Groundwater Transfer Review Summary Form

Transfer/PA # T- 14408

Application: T-14408

Applicant Name: Michael & Heidi Hanson

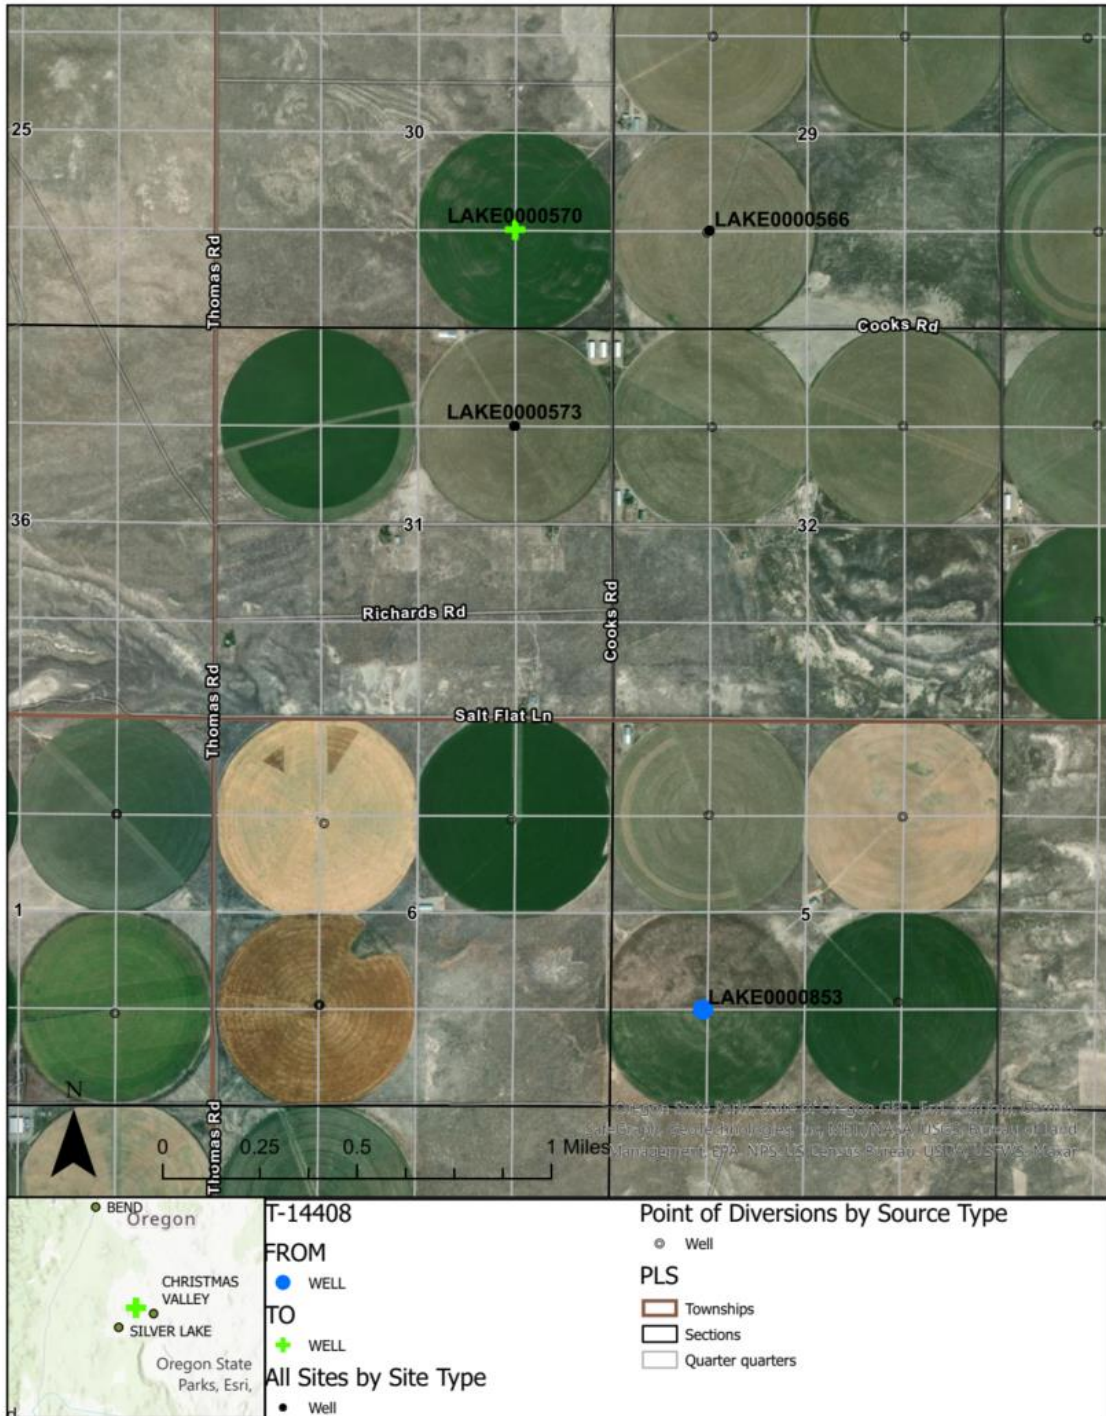
Yes (checked) No Comments: Groundwater in the Fort Rock Valley-Christmas Valley area (Fort Rock Classified Area) is identified as a single groundwater system. Groundwater is found in both a shallower predominantly basin-fill sediment unit and a deeper predominantly volcanic rocks and sediments unit below. The predominantly basin fill sediment unit and the predominantly volcanic rocks and sediment unit both readily yield groundwater, and the two units are hydraulically connected.

Miller (1986) describes the groundwater source as the main groundwater reservoir. That reservoir includes groundwater in different geologic units. The reservoir has three characteristics. First, the “natural” groundwater level changes less than 1.5 feet annually, indicating the system is highly modulated. Second, the 1980s potentiometric surface was approximately 4292 feet elevation amsl basin-wide with Silver Lake an exception. Third, the reservoir consists of numerous water producing zones in several formations, all having an essentially common potentiometric level, and all being very transmissive in general.

The authorized wells produce groundwater from water bearing zones within the predominantly basin-fill sediment and/or the underlying predominantly volcanic rocks and sediment unit of the main groundwater reservoir. The proposed wells will also produce groundwater from water bearing zones within the main groundwater reservoir.
